# City of Cottonwood

## Engineering Dept.

Date: 06.24.2016

Response to comments submitted in regards to City of Cottonwood, IFB 2016-PW-10.

**CITY OF COTTONWOOD**  
**RIVERFRONT WATER RECLAMATION FACILITY**  
 CIVIL SITE PLAN HORIZONTAL CONTROL

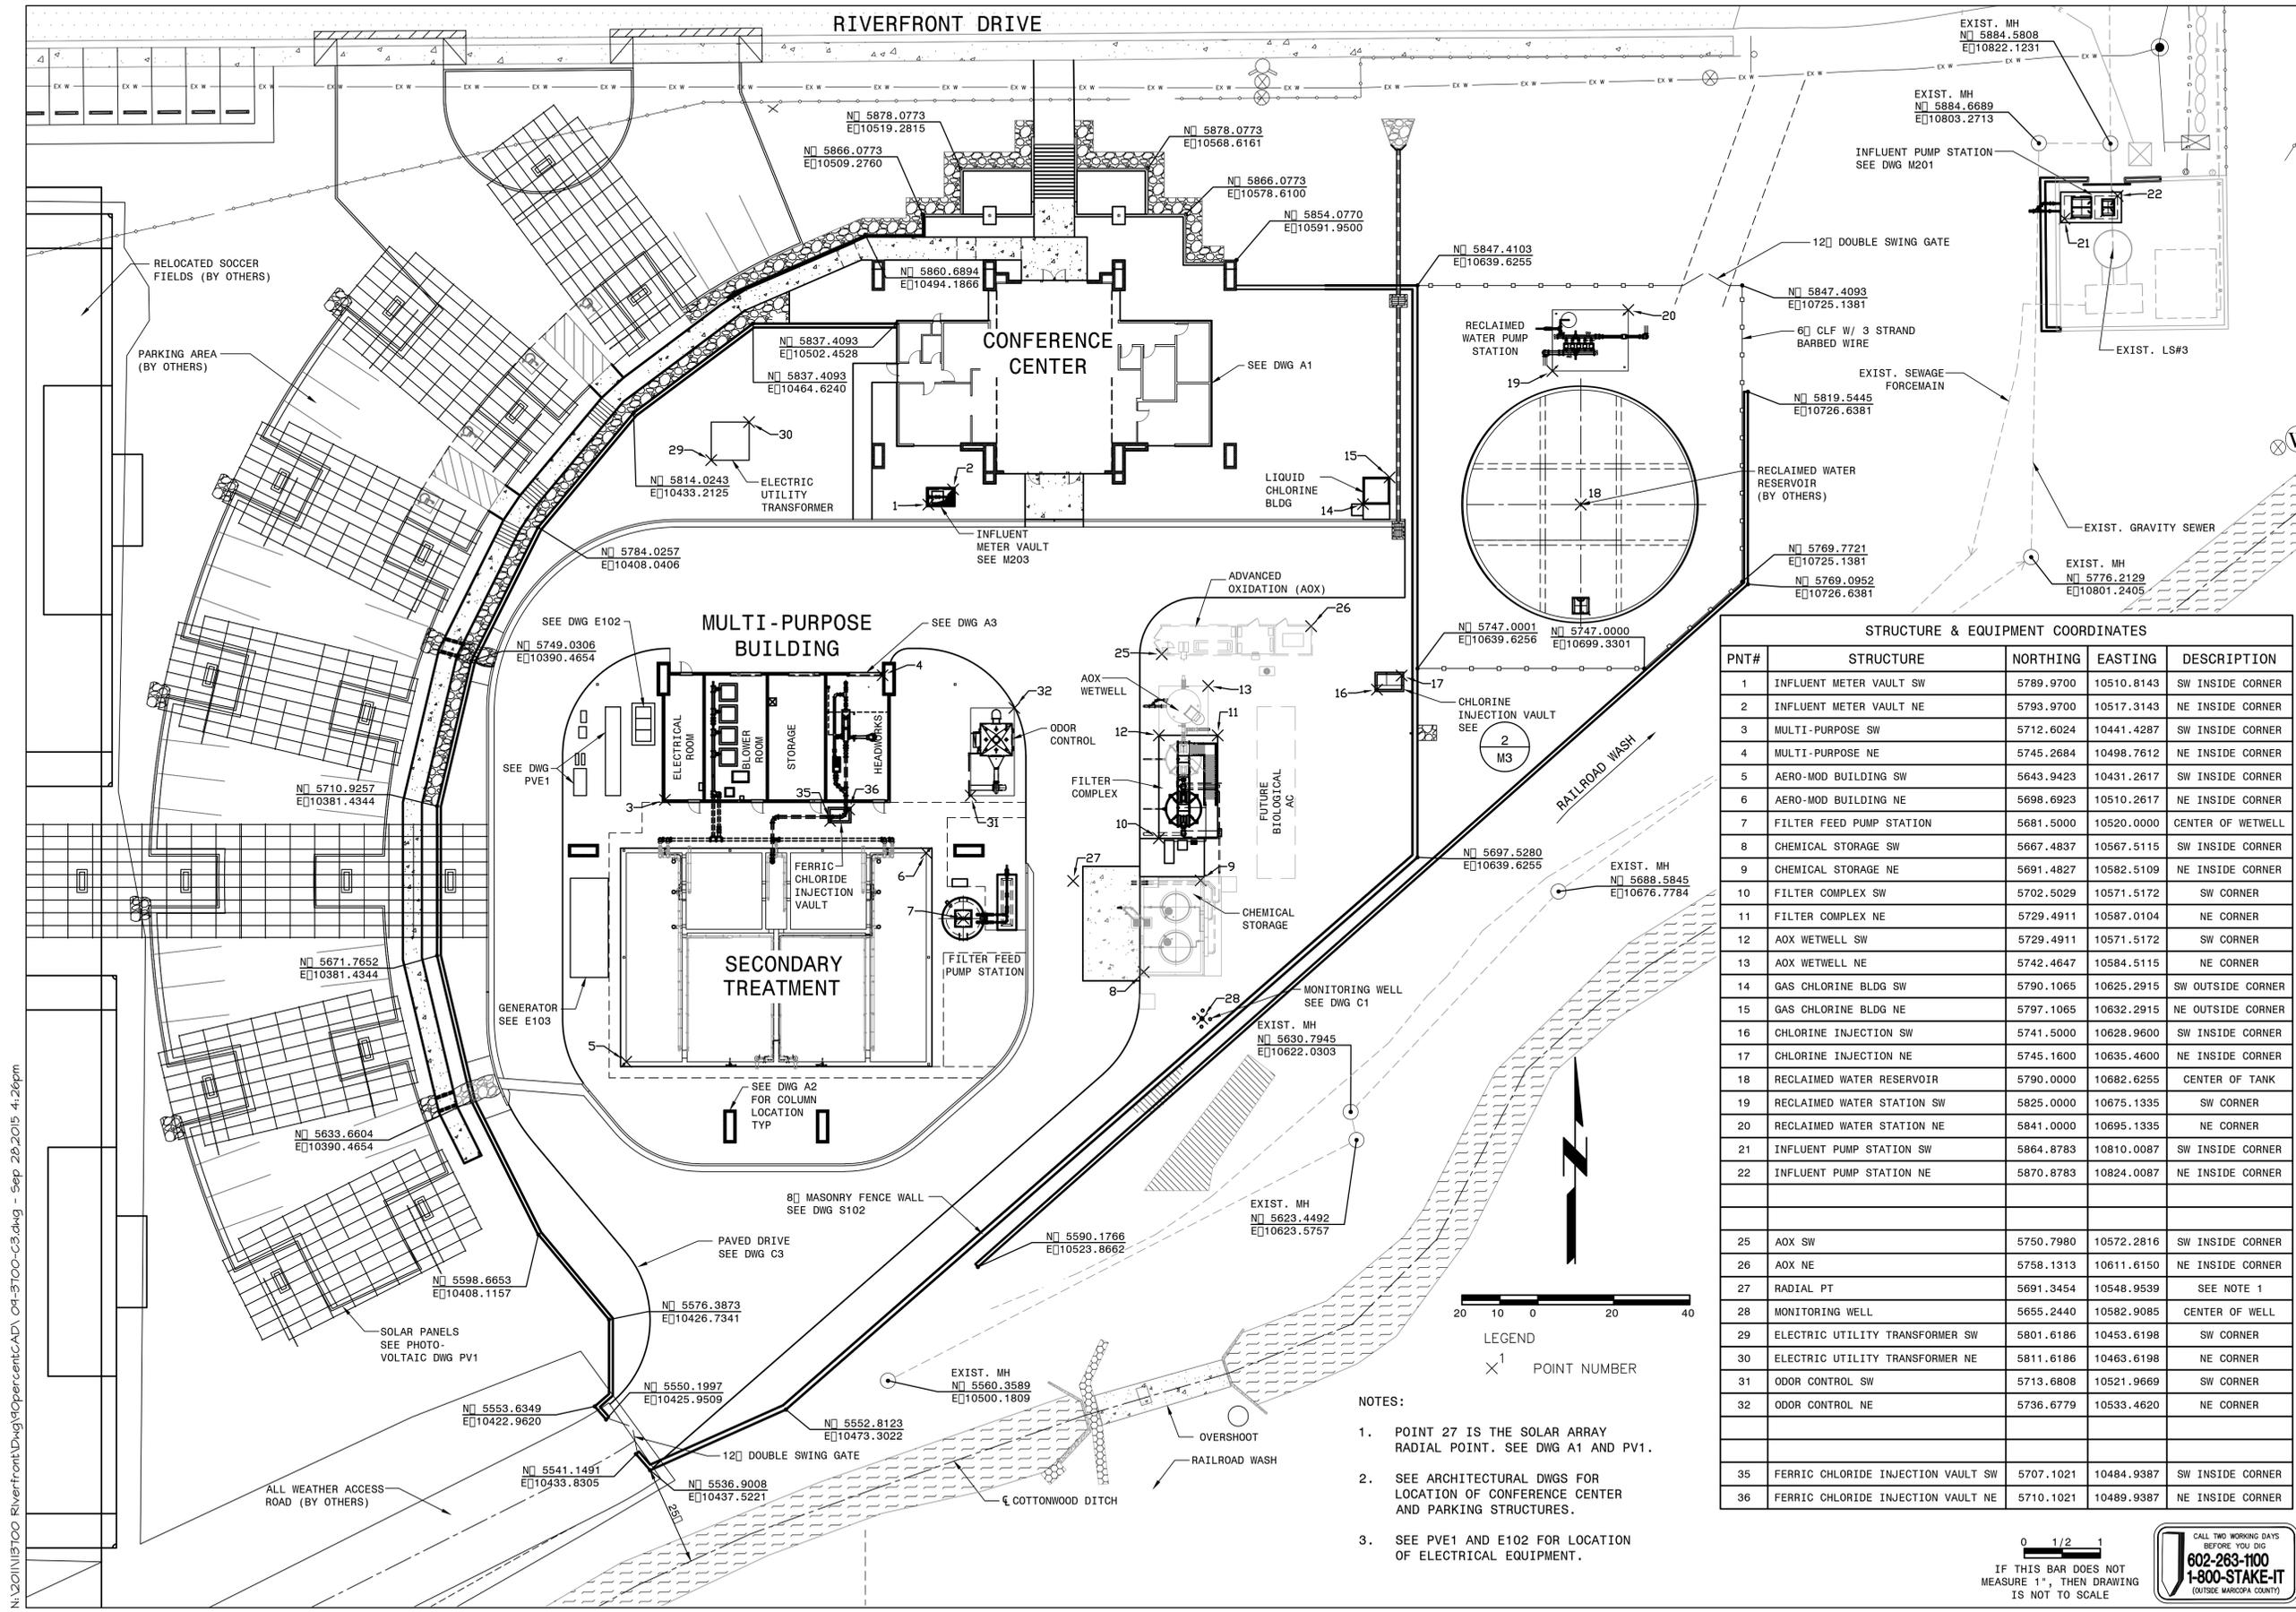
14. We would also like to see the layout and general arrangement of the site.

*See response to #8 above.*

SITE YARD PIPING PLAN 2

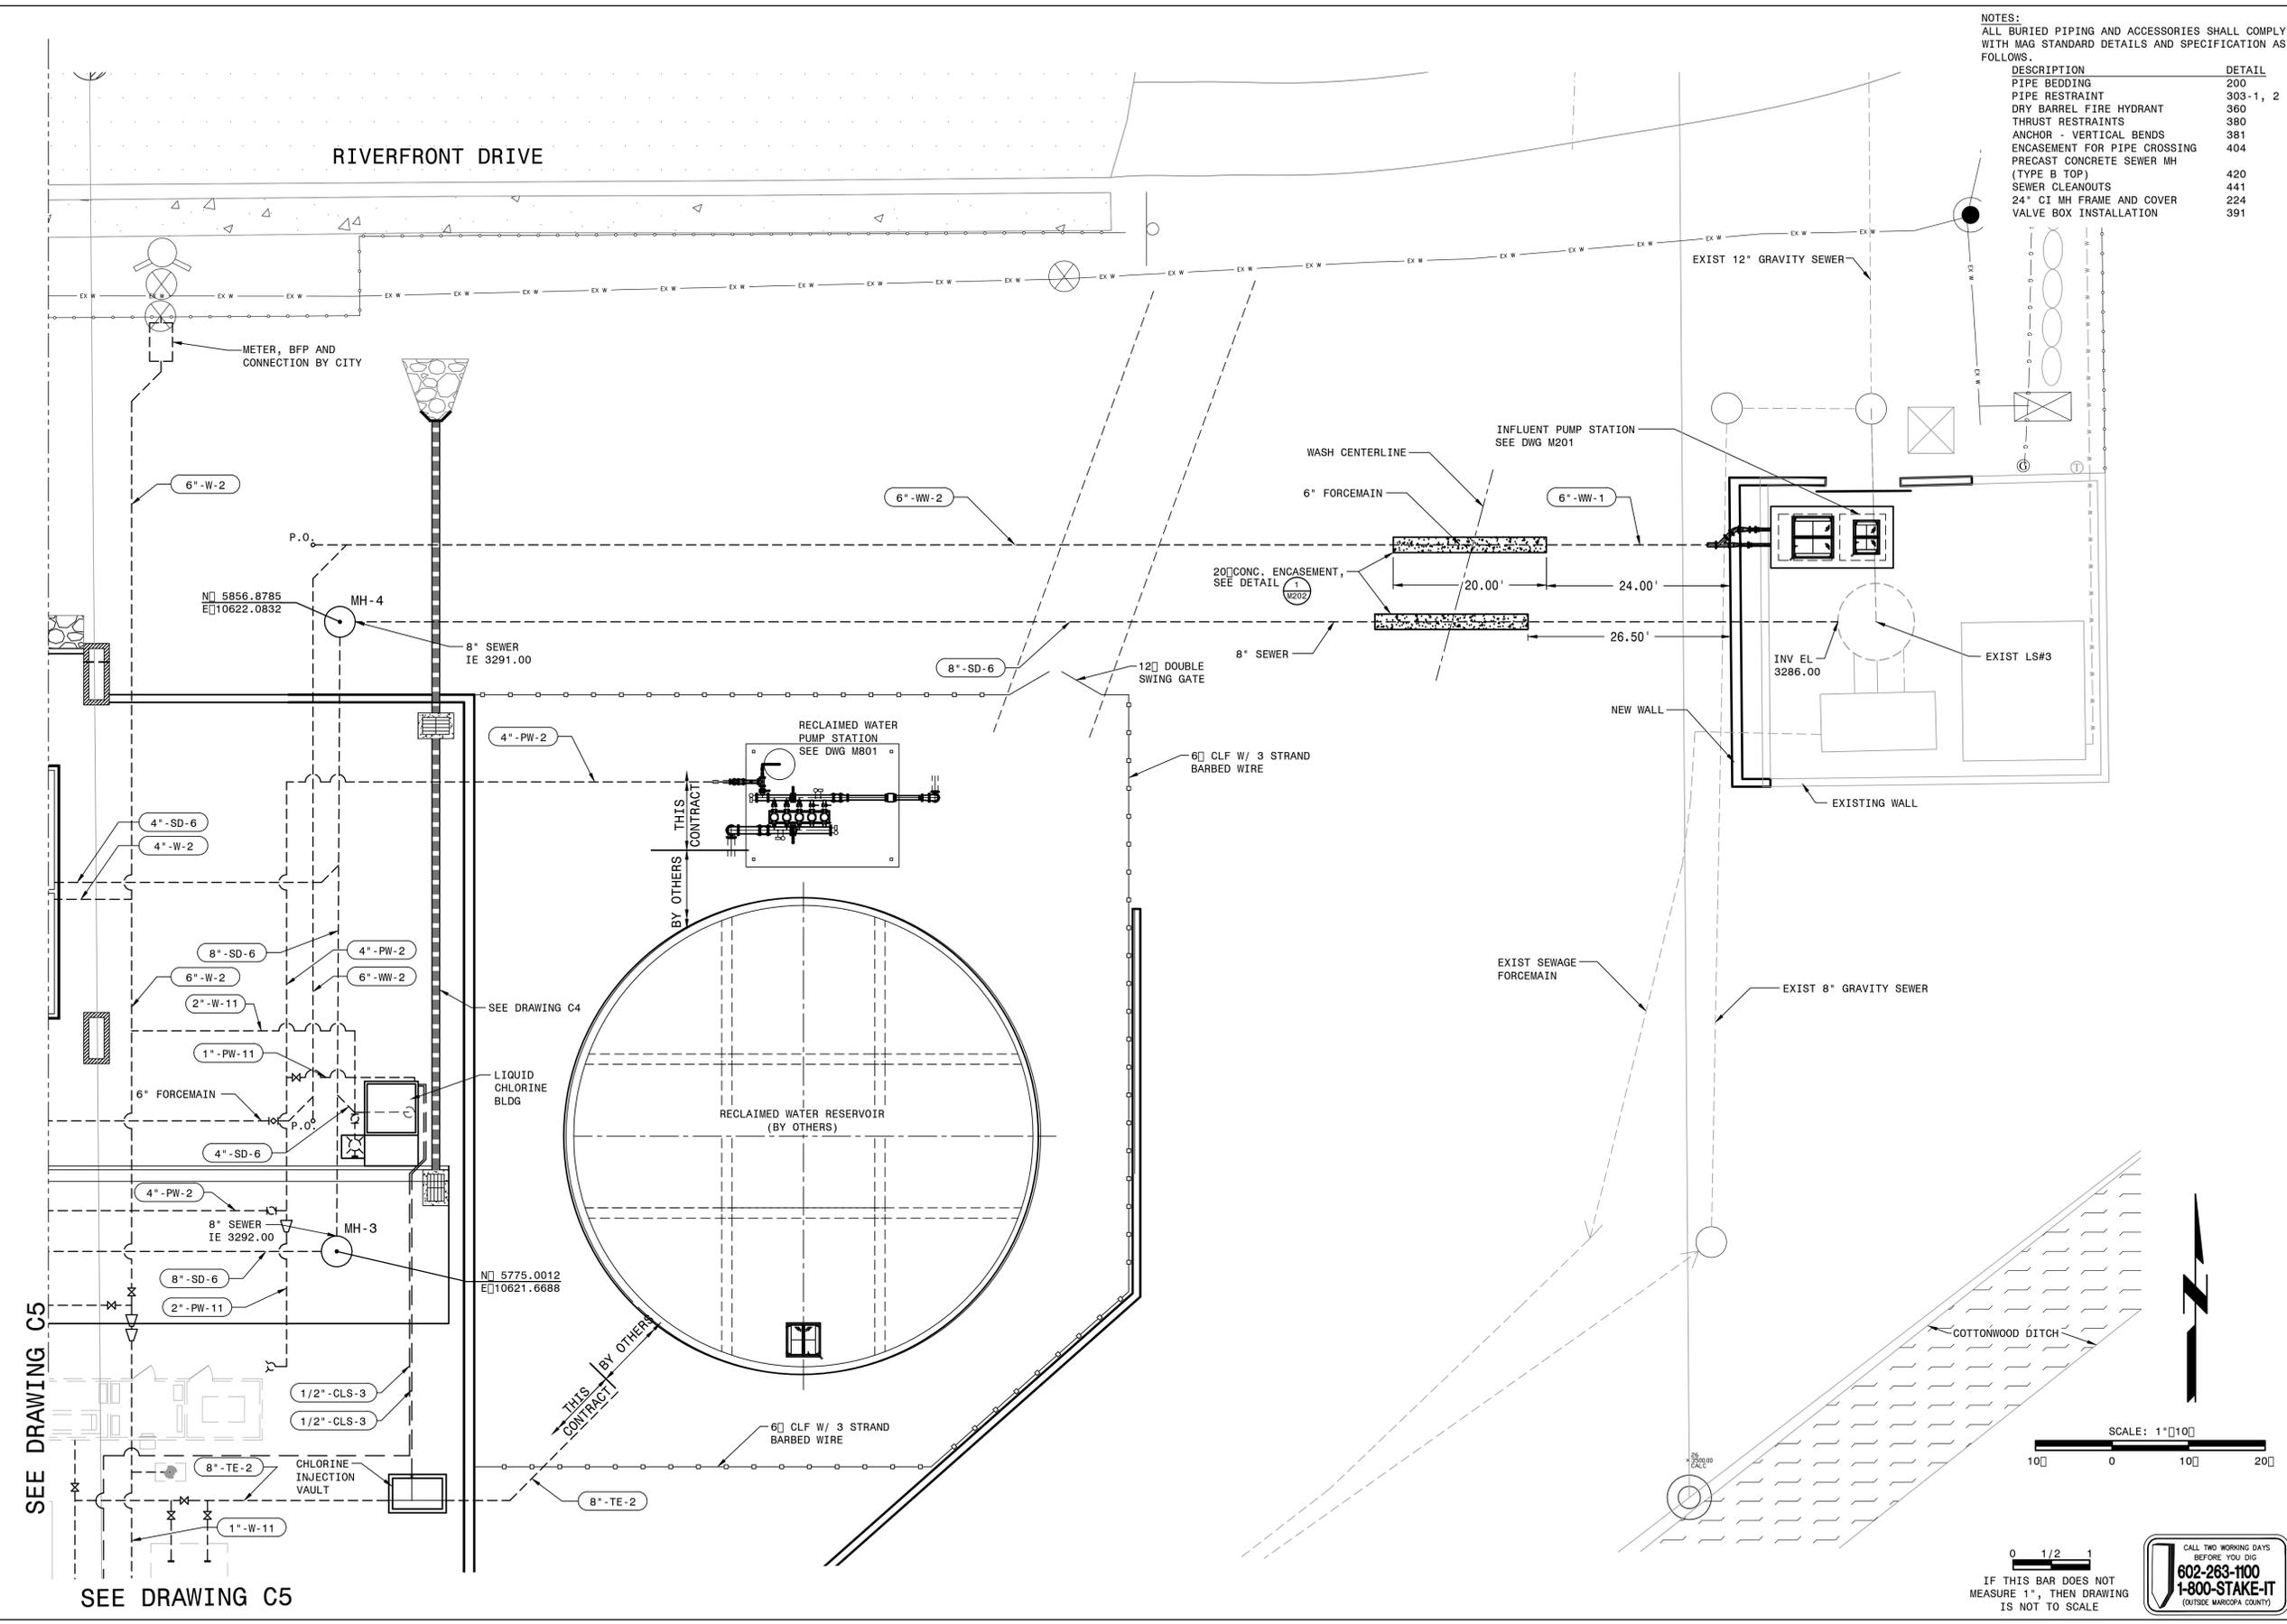
6. Where is the specific location of the tank?

*See site plan attached (Sheet C6).*
